SUBMITTER No.	364	ISSUE REFERENCE:	13001
SUBMITTER TYPE	Government	TOR CATEGORY	Project Approvals
NAME	DEEDI (Fisheries Qld)	RELEVANT EIS SECTION	Volume 1 – Chapter 2 – 2.2.2 – Table 3

SUBMITTER No.	364	ISSUE REFERENCE:	13002 / 17144
SUBMITTER TYPE	Government	TOR CATEGORY	Project Approvals
NAME	DEEDI (Resource Planning, Geological Survey of Qld)	RELEVANT EIS SECTION	Volume 1, Project Overview (Chapter 2 – Project Approvals) Section 2.2.2 – State Legislation & Planning Policies

Figure 1. Rail Infrastructure Crossings (Sheet 1 of 5)

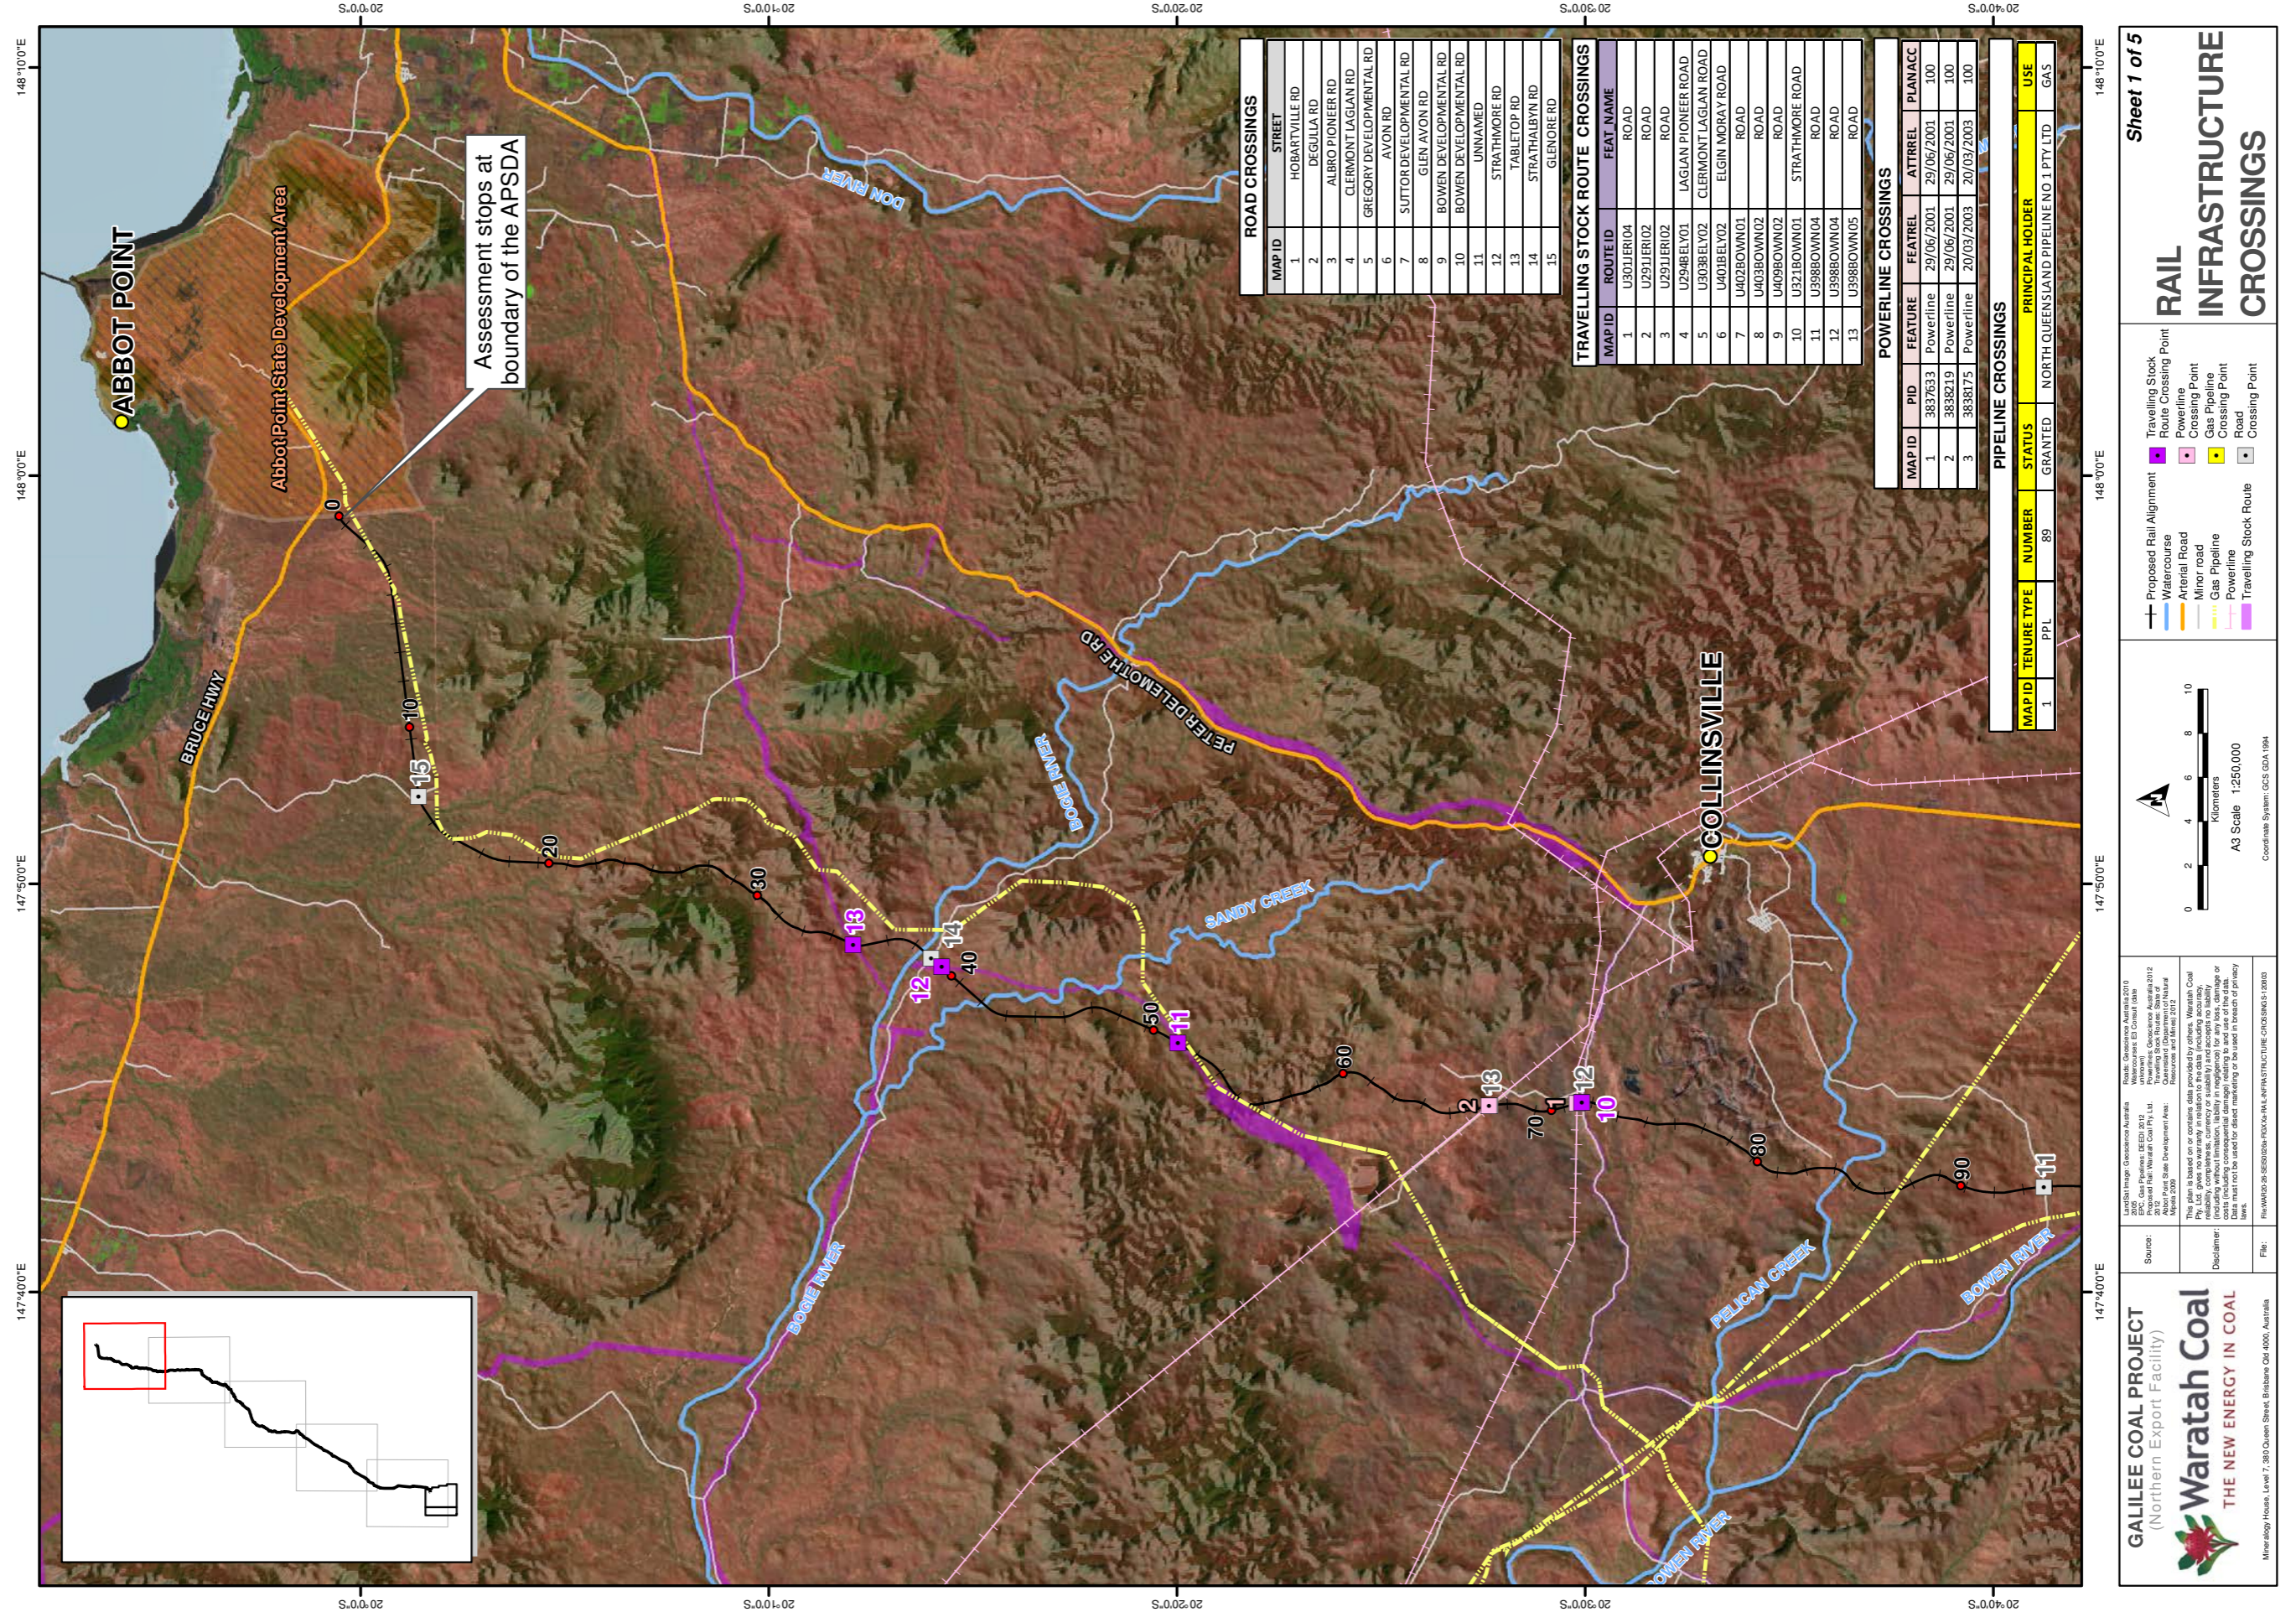
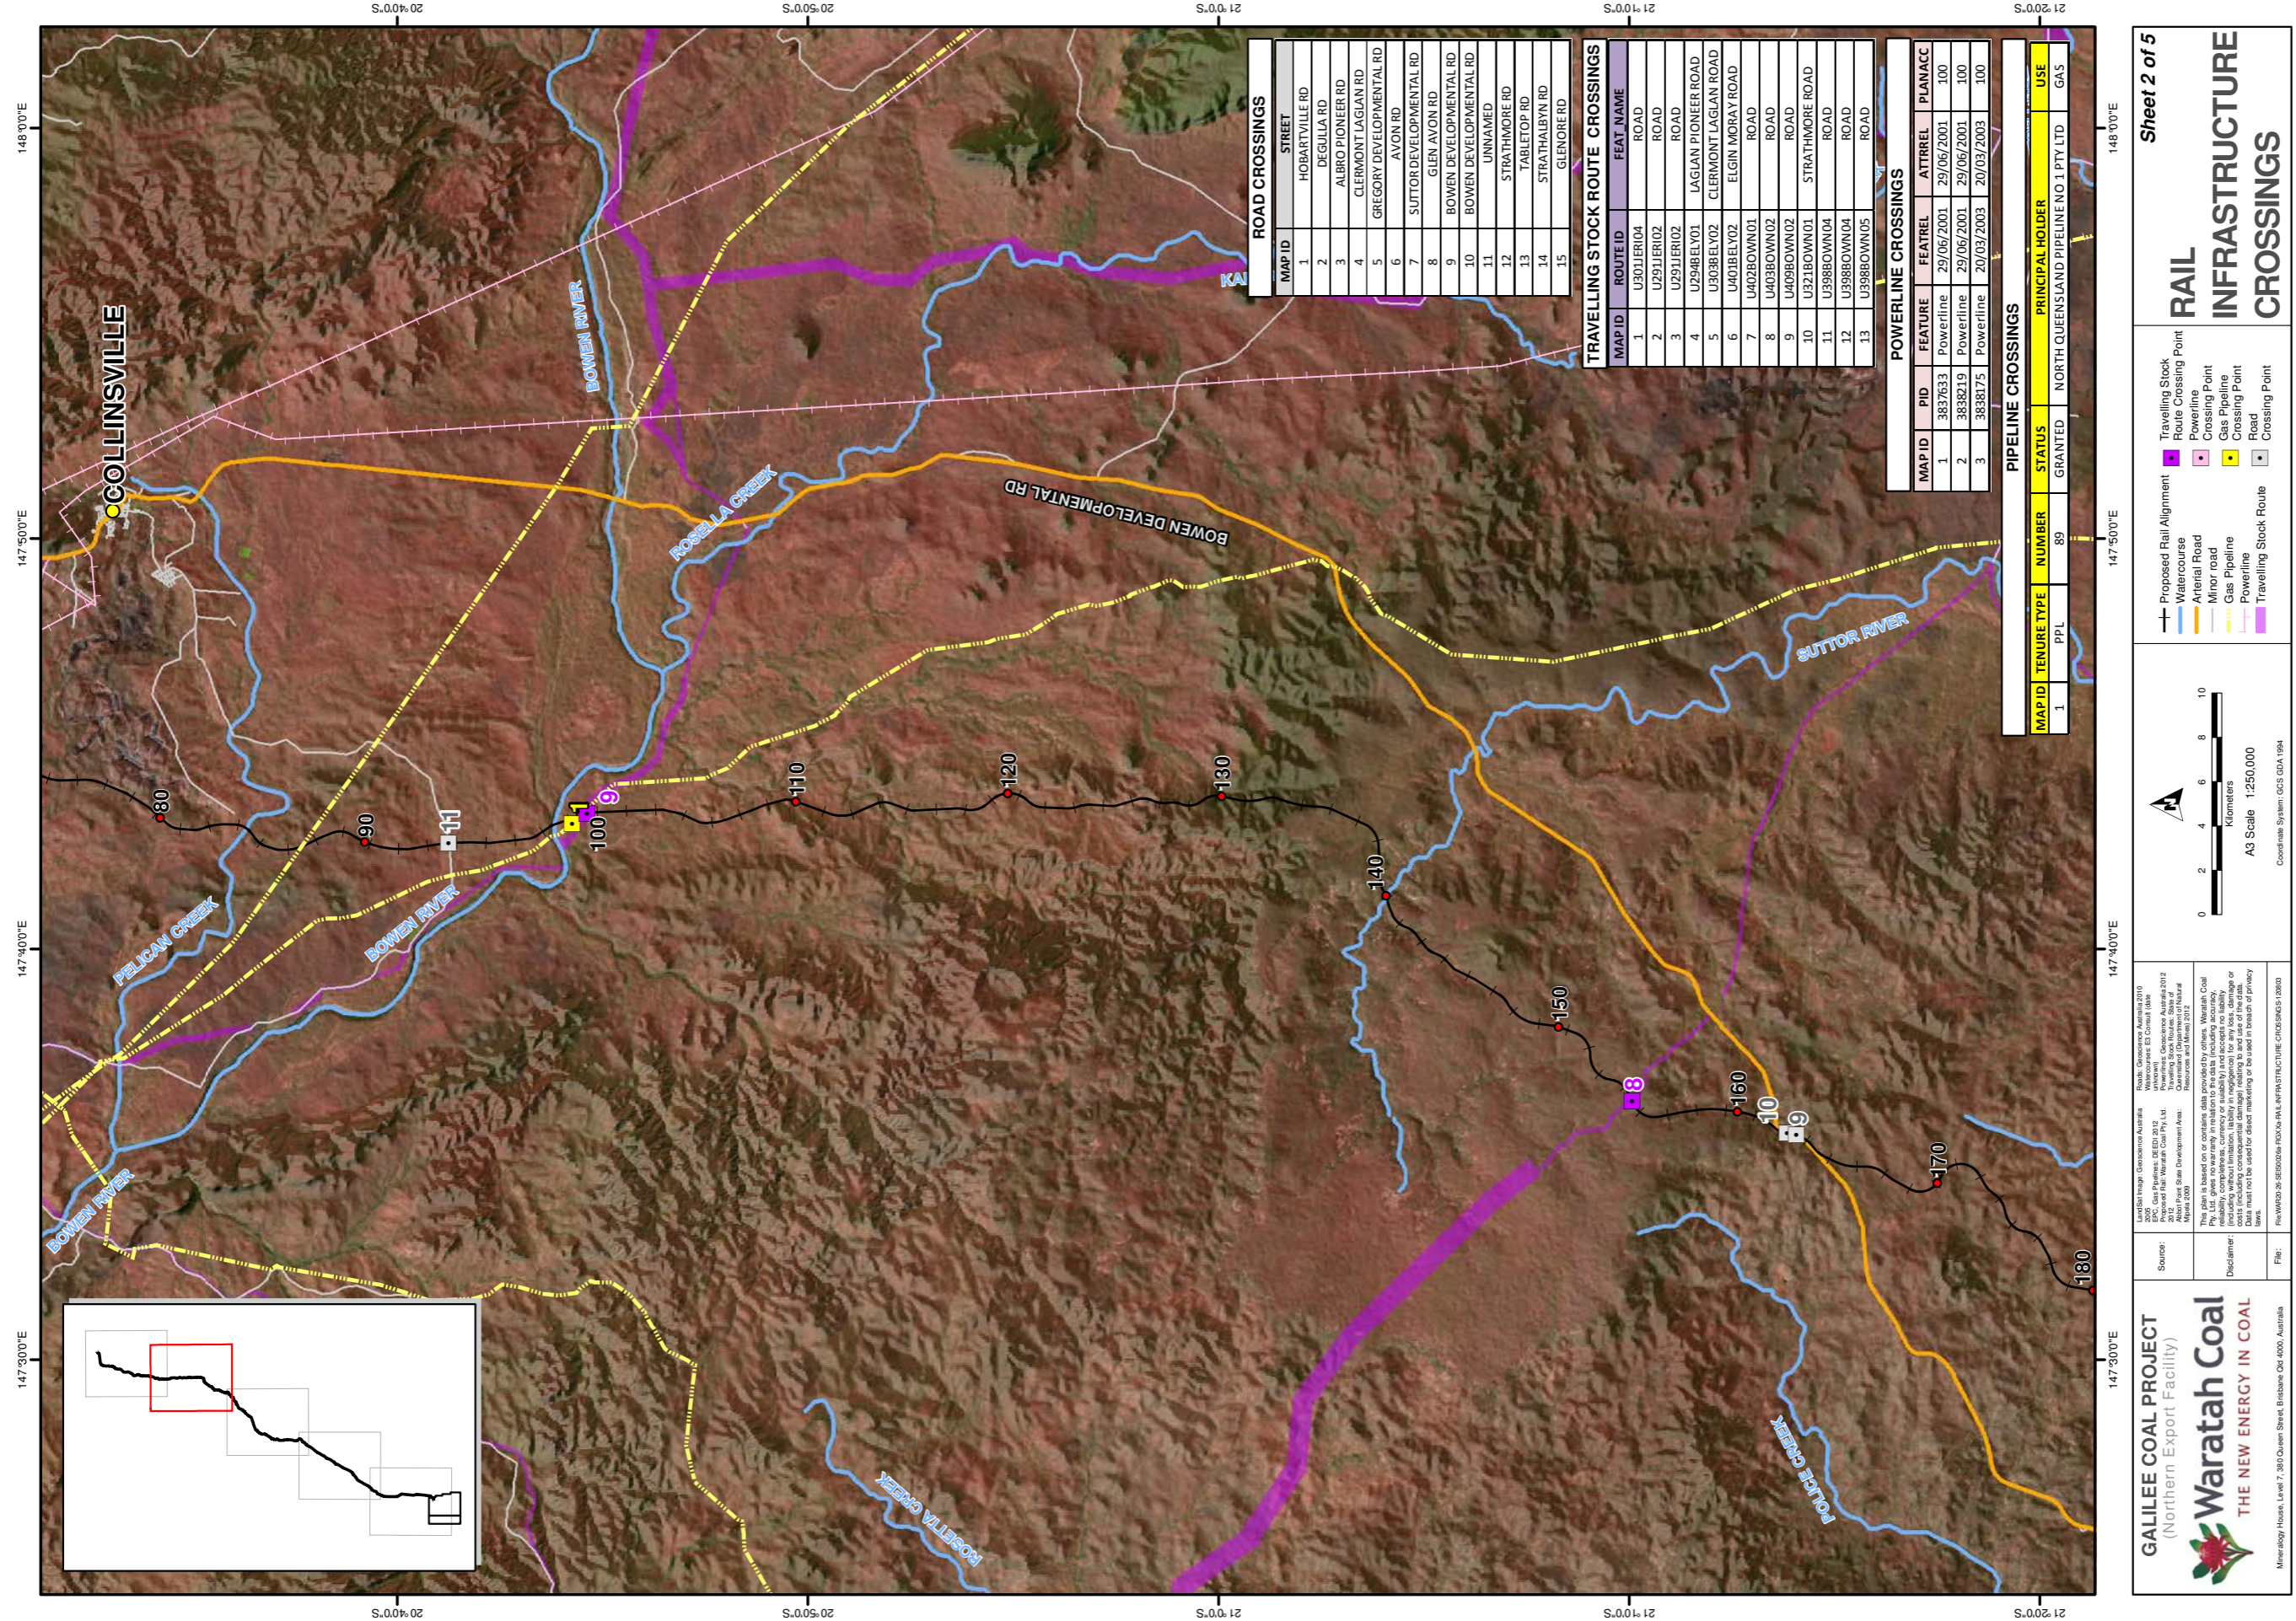
This section lists the relevant legislation affecting the Project. The proposed rail alignment traverses a constructed pipeline, the North Queensland Gas Pipeline (PPL 89).

Provisions of the *Petroleum and Gas (Production and Safety) Act 2004* (P&G Act) deal with activities affecting pipelines. This Act has not been identified in the draft EIS as part of the list of relevant legislation.

Reference should be made to the P&G Act, particularly Sections 807 and 808, which provide, respectively, that a person must not construct or place a structure on pipeline land without the prior consent of all the pipelines licence holders, and that a person must not change the surface of pipeline land without the prior consent of all the pipelines licence holders.

In accordance with the *Petroleum and Gas (Production and Safety) Act 2004* (P&G Act), Waratah Coal will obtain the necessary consents prior to undertaking any works over or near the subject pipeline.

Future studies regarding the portion of the rail alignment that traverses the North Queensland Gas Pipeline (PPL89) will take into account the provisions of the P&G Act. See Figure 1 (Sheets 1 to 5) on the following pages.
